Vermont Agency of Transportation
RECEIVED
 CK'D BY MEM OK'D BY
 Apr. 24, 2015
 RESUBMIT
 BY C. Carlson DATE 04-10-2015

Job #: 15790
 Company: Champlain Constr.
 Project: River St. BRF3000(16)
 Address: Rutland, VT
 Date: 02/03/15
 Scale: N.T.S.

Elevation View

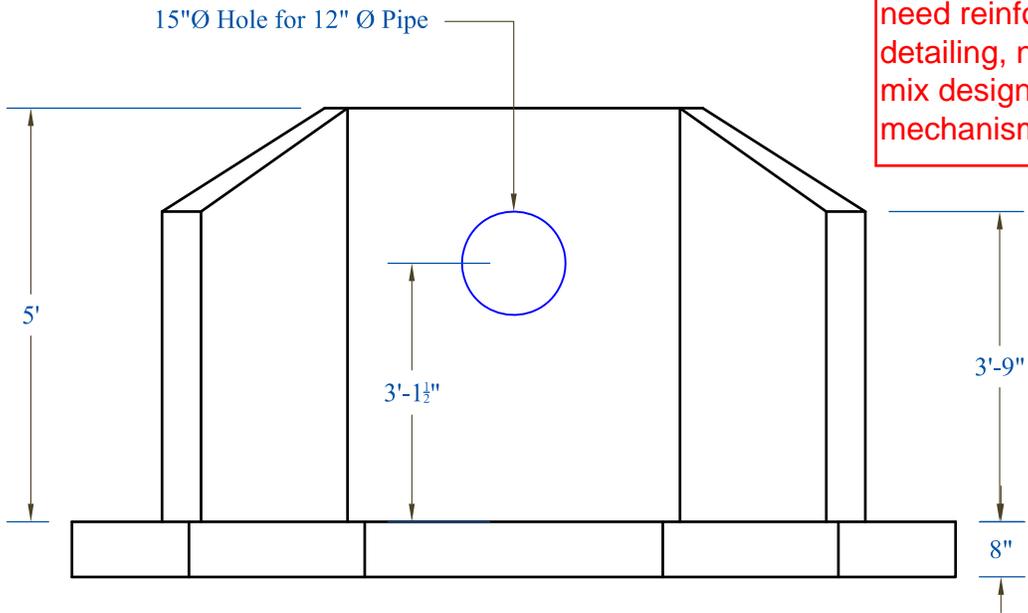
This item needs to meet all section of section 540, need reinforcing steel detailing, need concrete mix design, lifting mechanism
